**REMARKS**

Serial No.: 10/081,543  
Amendment to Office Action of September 27, 2004

**Amendment to the Drawings:**

Fig. 1

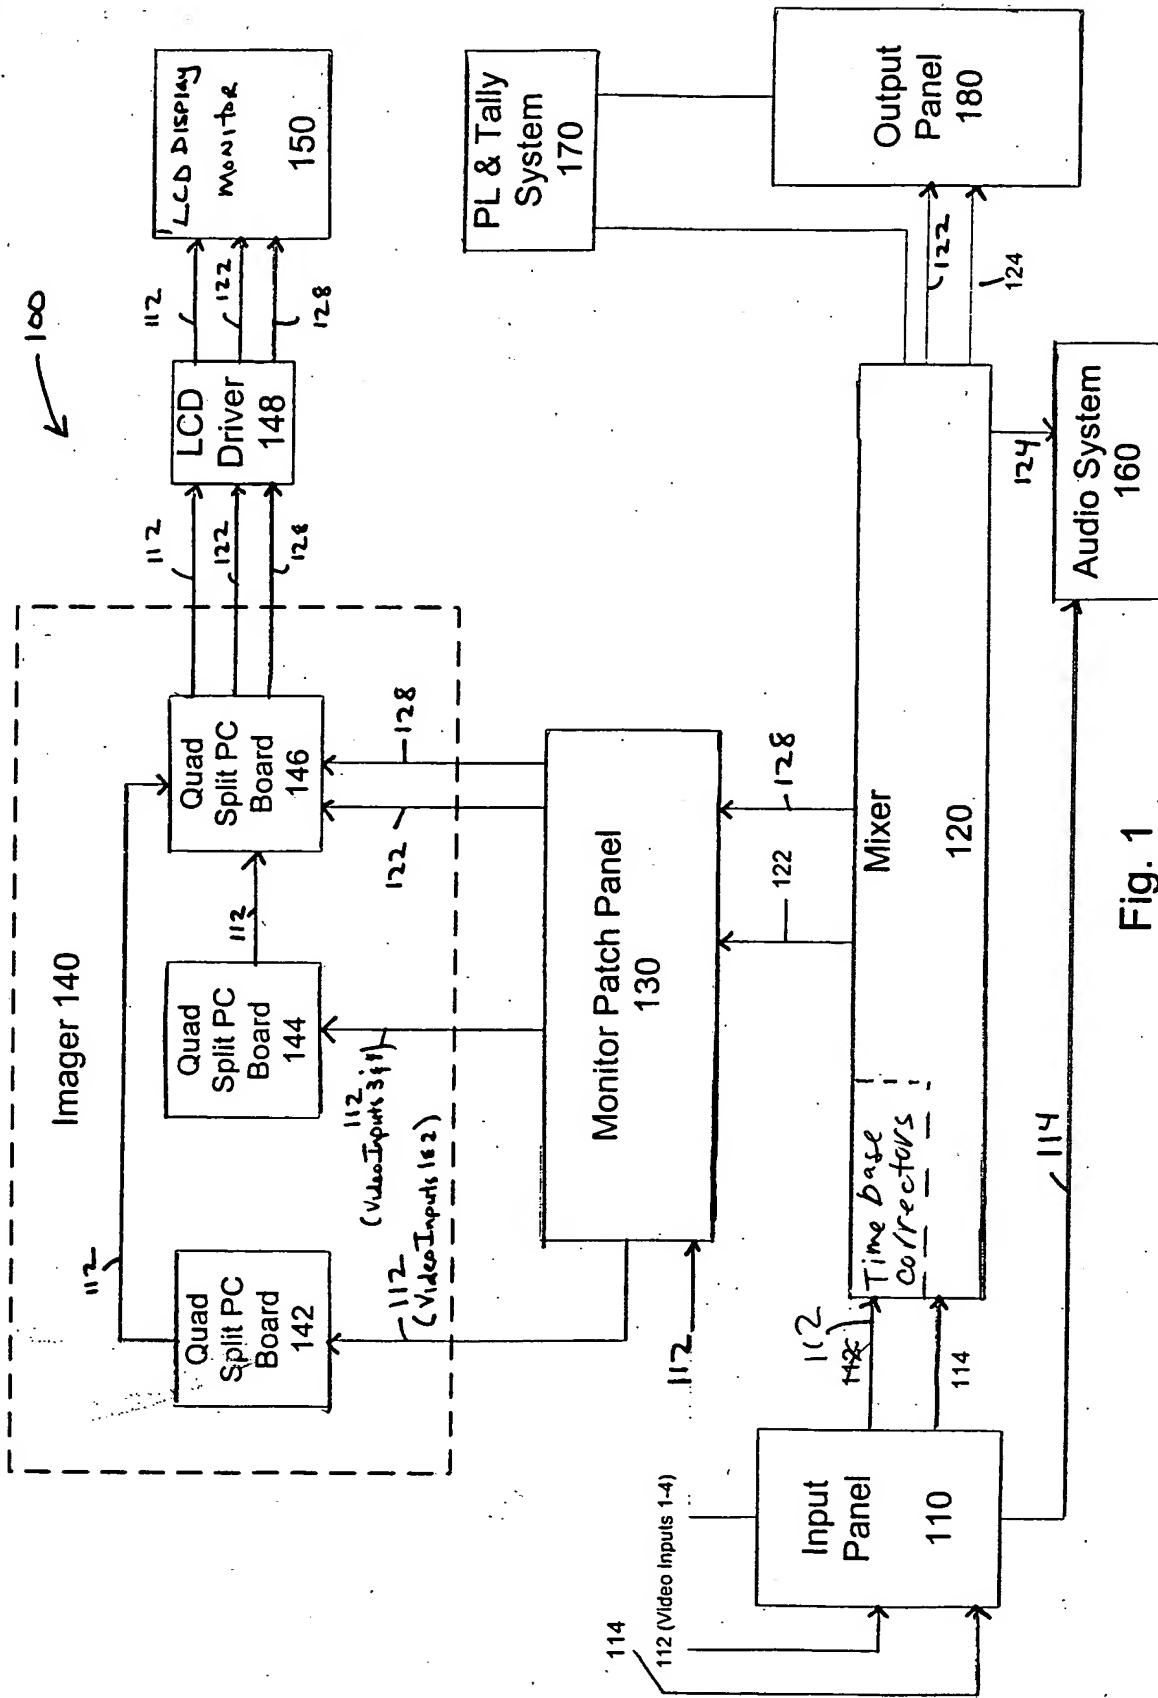
The Examiner has objected to the drawings under 37 CFR 1.83(a) stating that the “at least two time base correctors” feature must be shown or must be canceled from the claim(s). In response, FIG. 1 has been amended to show the “at least two time base correctors” feature of mixer 120. Support for the amendment is found throughout the specification, e.g., page 9, lines 11-19.

The attached sheet of drawings includes changes to FIG. 1. As shown on the attached annotated sheet, the amendment shows the “at least two time base correctors” feature of mixer 120. Support for the amendment is found throughout the specification, e.g., page 9, lines 11-19. No new matter has been added. A replacement sheet incorporating the proposed change is also attached.
